Lantzke Road TPS3/SA144 Amendment and Structure Plan

Title: Shire of Denmark Town Planning Scheme 3 Amendment 144

SCHEDULE OF MODIFICATIONS

Lantzke Road Structure Plan

LOCAL STRUCTURE PLAN
 LOT 3 MCLEAN ROAD AND LOTS 4, 5, 6 & 7 LANTZKE ROAD, DENMARK
PLAN 1

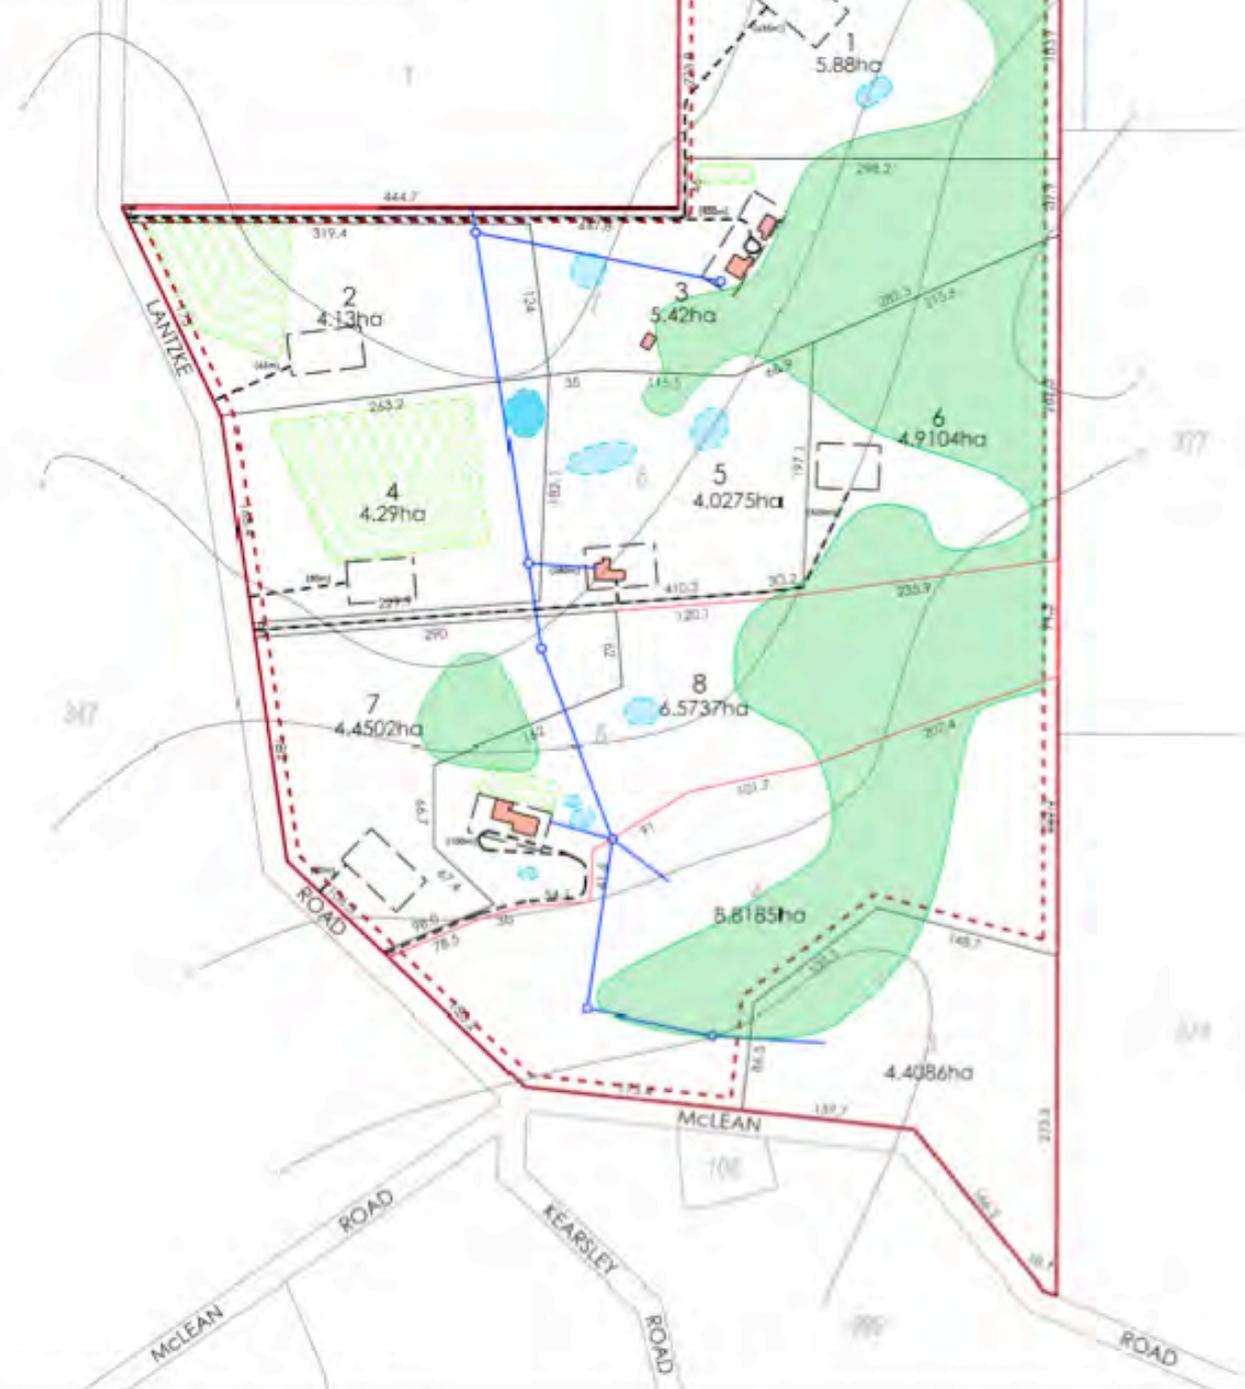
There appears to be future building envelopes in BAL-40.

The Guidelines state that the strategic planning proposal should be located in areas with the least possible risk of bushfire. Proposed Lots 1, 3, 6 and 9 have an extreme BHLand are not supported.

Battle-axe legs are to be avoided in bushfire prone areas. They are only considered an acceptable solution 'where no alternative exists'. The BMP has not adequately justified that there is no alternative.

The building envelope on proposed Lot 6 has a portion within the BAL-40 classification. The building envelope location should be adjusted to ensure not part is within the BAL-40 classification.

<p>that it would never be contemplated and is completely inappropriate.</p> <p>However, retaining the potential (as an 'SA' use in the Scheme) would allow for the existing tourist business (the gallery & studio) to expand and potentially increase it's viability.</p> <p>Any application would be referred widely for comment, only approved at Council's discretion and highly likely to attract a considerable road upgrade condition.</p>	
There is the potential for some future residences to be impacted by odour, noise, dust and spray drift from horticulture/viticulture activities.	Buffers to horticultural land use are in place, as shown on the site characteristics plan appended to the structure plan.	Notate the Structure Plan to require buffer planting between proposed building envelopes and existing horticultural enterprises.
Portion of building envelope on proposed Lot 6 is classified BAL-40 in the BAL Contour Plan	There is room to adjust the building envelope to a safer location further to the east so no part of the building envelope is in the BAL-40 contour.	Adjust the location of the building envelope and lot boundary for proposed Lot 6 so not part of the building envelope is classified BAL-40.

The existing gallery and studio on Lot 5 Lantzke Road is outside the proposed building envelope on proposed Lot 7.	The gallery and studio has all necessary approvals, the building envelope just needs to be adjusted.	Adjust the building envelope location on proposed Lot 7 so as to locate the entire existing gallery and studio within its borders.
Buffers to horticultural uses from residences are recommended by the EPA and relevant WAPC guidelines.	Many buffers are in place but mechanisms should be introduced to the Scheme and Structure Plan making it clear that these are required to be retained and maintained over time.	Show the existing and required agricultural buffers between existing horticultural land uses and proposed building envelopes.
The creek line protection area that was previously included in the subdivision guide plan and Scheme provisions has been removed, this area requires protection and would benefit from rehabilitation.	Whilst the documentation argues that there is little water in this creek, it does form the head waters of the intermittent creek line that is the in Scotsdale Brook catchment. Protection of the creek line and rehabilitation of the area would bring environmental benefits.	Show a 20m wide creek line protection area in the Structure Plan

Submission S5
Attachment A

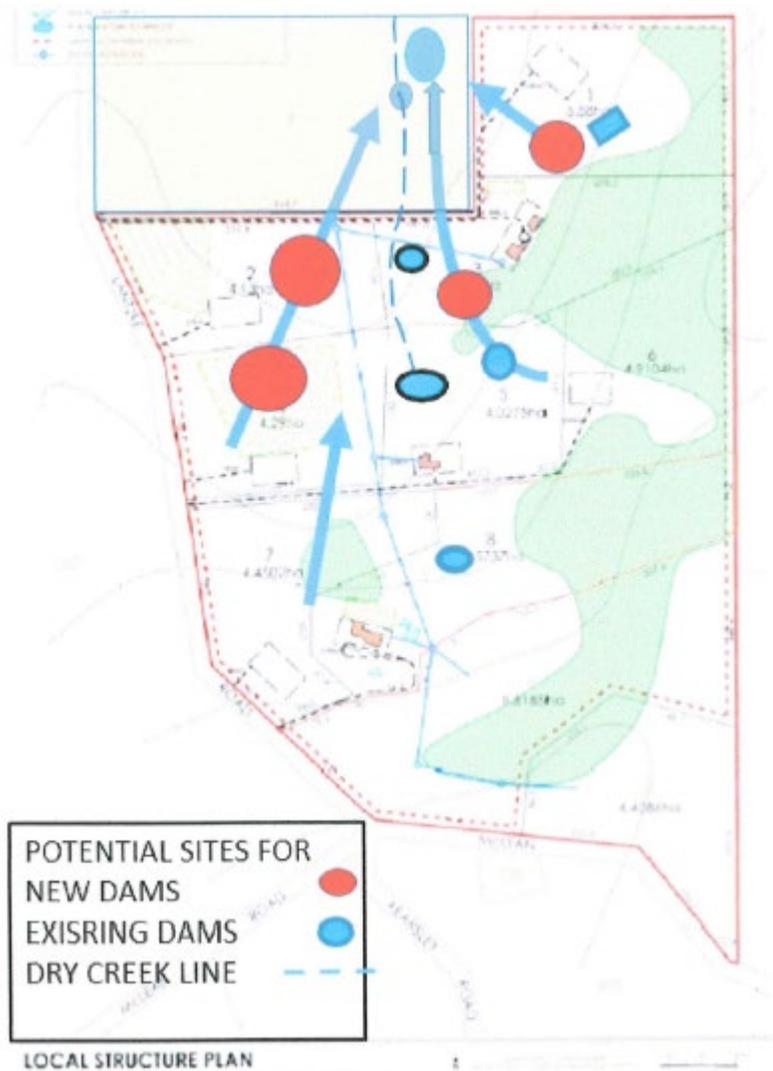
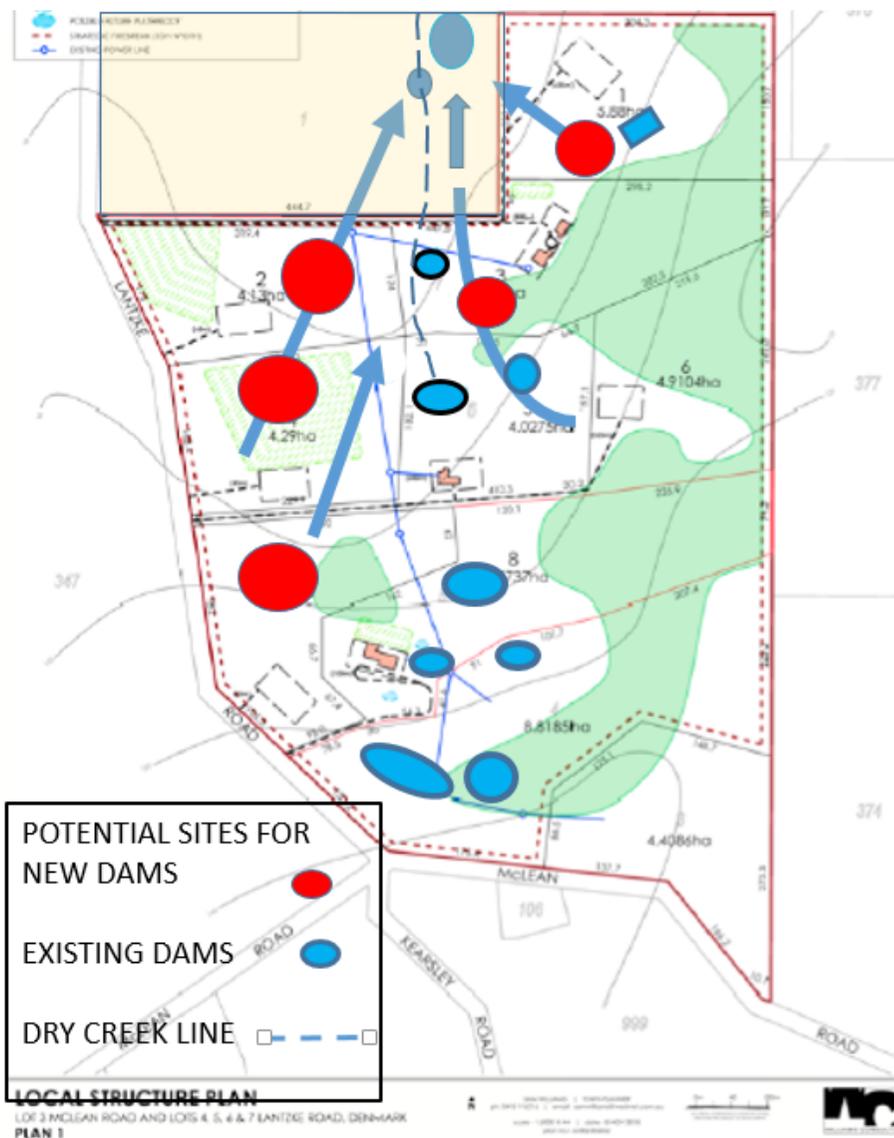
NOW
48.4 ha (119.6acres)
4 properties - 9 dams

- (Conclusions from Independent Assessment)
- There has been a decline in rainfall and stream flow in the SW since the mid-1970s
- The creek has never had water flow in the last 30 years.
- This is due to the effect of collection into dams
- All of the existing dams do not appear to overflow during heavy rainfall periods.

AFTER SUBDIVISION
48.4 ha (119.6acres)
9 properties - ??? dams

9.1.1d ISSUES AND PROPOSED MODIFICATIONS

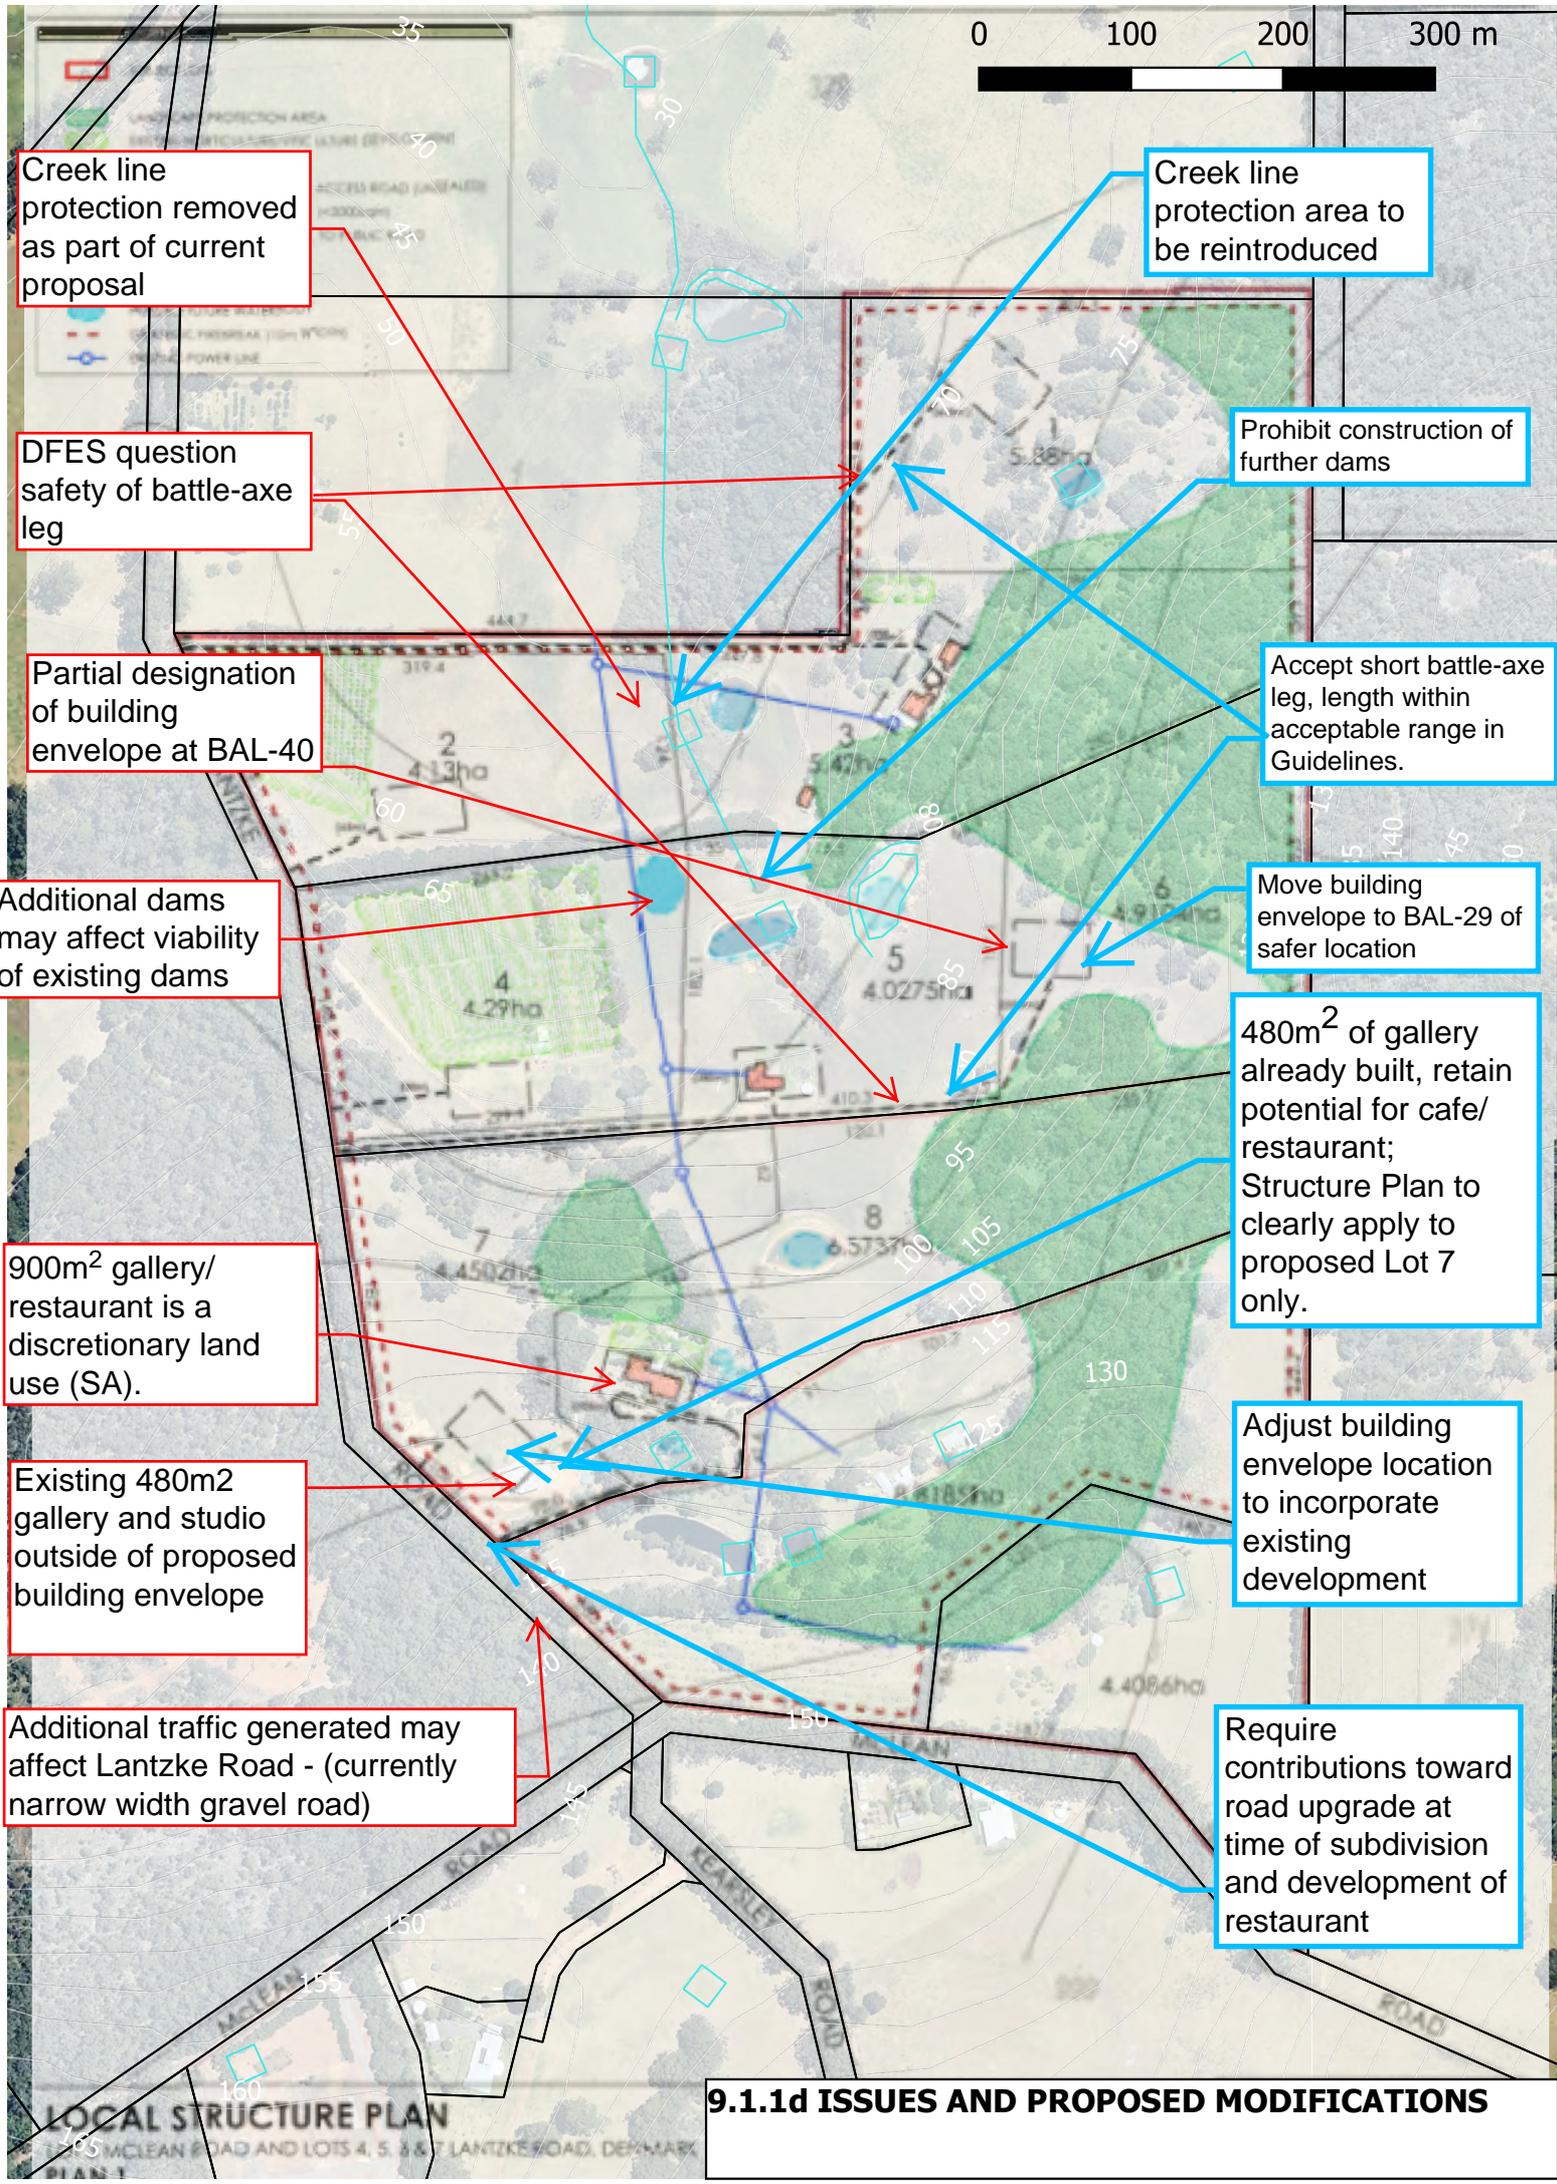
Creek line protection removed as part of current proposal

DFES question safety of battle-axe leg

Partial designation of building envelope at BAL-40

Additional dams may affect viability of existing dams

900m² gallery/restaurant is a discretionary land use (SA).

Existing 480m² gallery and studio outside of proposed building envelope

Additional traffic generated may affect Lantzke Road - (currently narrow width gravel road)

Creek line protection area to be reintroduced

Prohibit construction of further dams

Accept short battle-axe leg, length within acceptable range in Guidelines.

Move building envelope to BAL-29 of safer location

480m² of gallery already built, retain potential for cafe/restaurant; Structure Plan to clearly apply to proposed Lot 7 only.

Adjust building envelope location to incorporate existing development

Require contributions toward road upgrade at time of subdivision and development of restaurant
